## Product Change Notice (PCN)

**PCN Number:** PCN-0450214R

SD-SN series

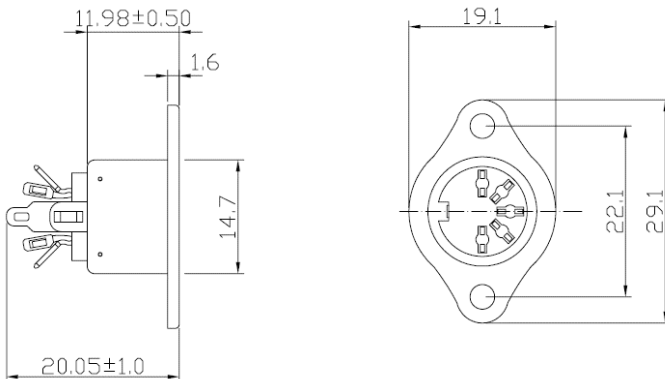
Mechanical dimension changes to connector housing:

Old Housing Dimensions

New Housing Dimensions
